1st Submittal
Comments in green were made by
Development Services reviewer Sara
Siggue. Please reach out to her at
ssiggue@auroragov.org for any
comments or questions.

INFRASTRUCTURE SITE PLAN METRO CENTER - PARCEL B

INFRASTRUCTURE SITE PLAN

SHEET
C2
2 OF 19

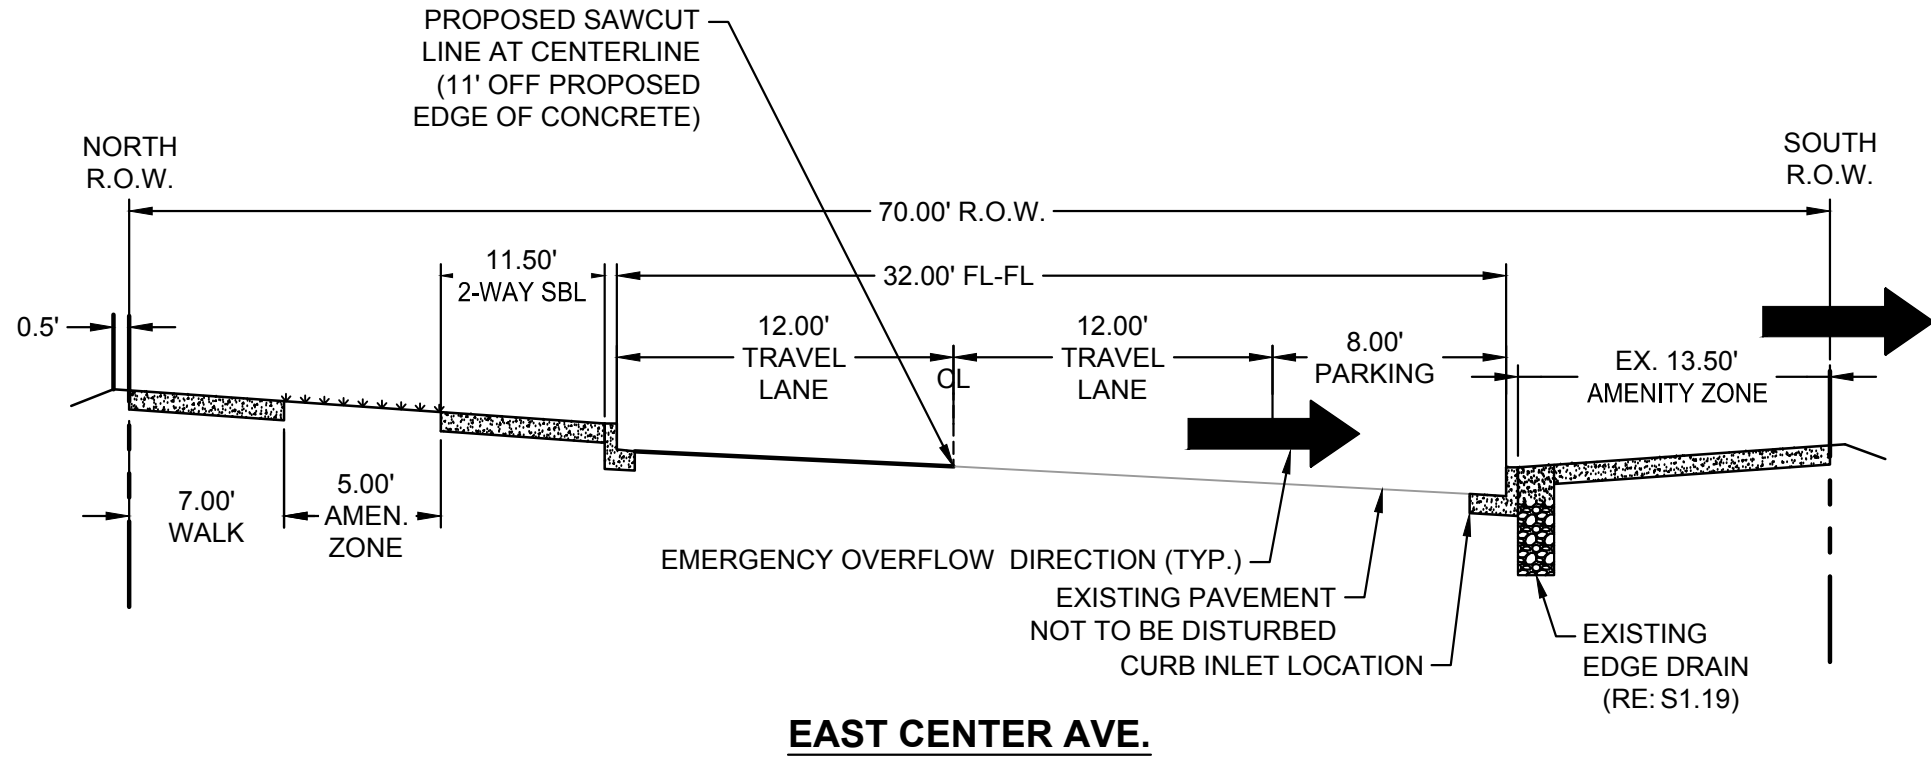
sections will need to be updated per the new design

Section added for the northern portion Fraser that has attached walk per comment.

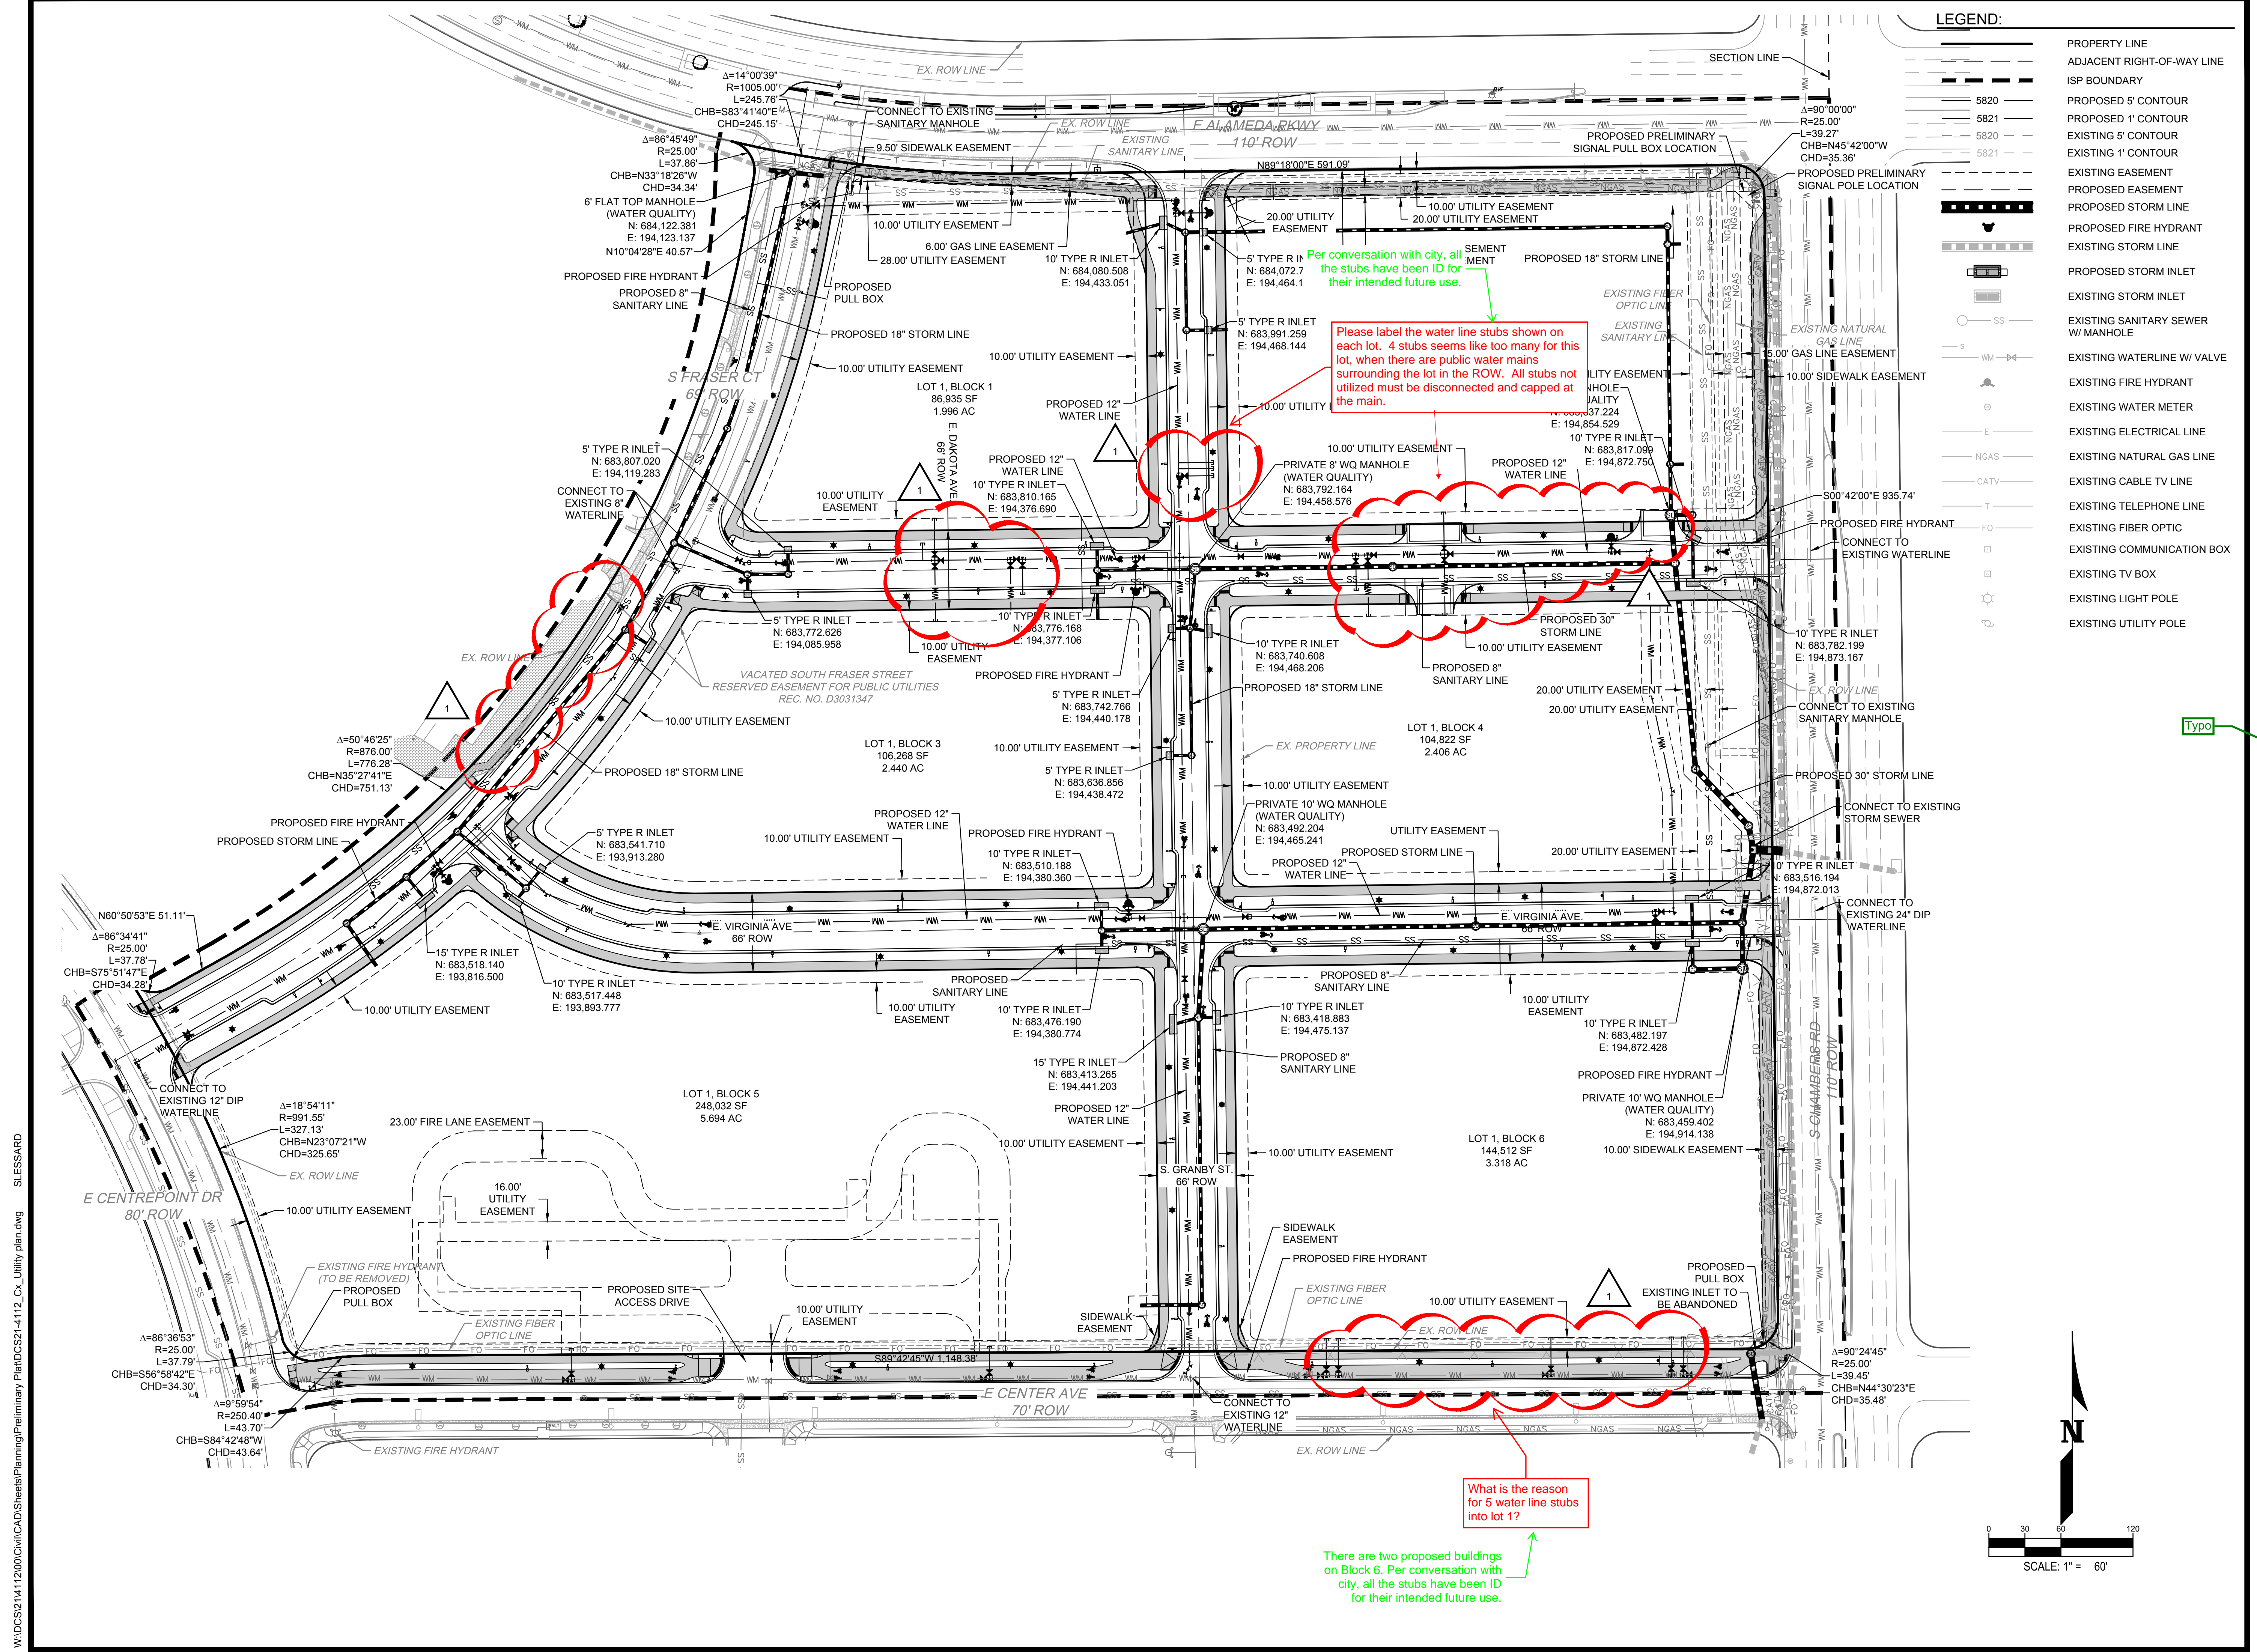
Please label the water line stubs shown on each lot. 4 stubs seems like too many for this lot, when there are public water mains surrounding the lot in the ROW. All stubs not utilized must be disconnected and capped at the main.

What is the reason for 5 water line stubs into lot 1?

Per conversation with city, all the stubs have been ID for their intended future use.

There are two proposed buildings on Block 6. Per conversation with city, all the stubs have been ID for their intended future use.
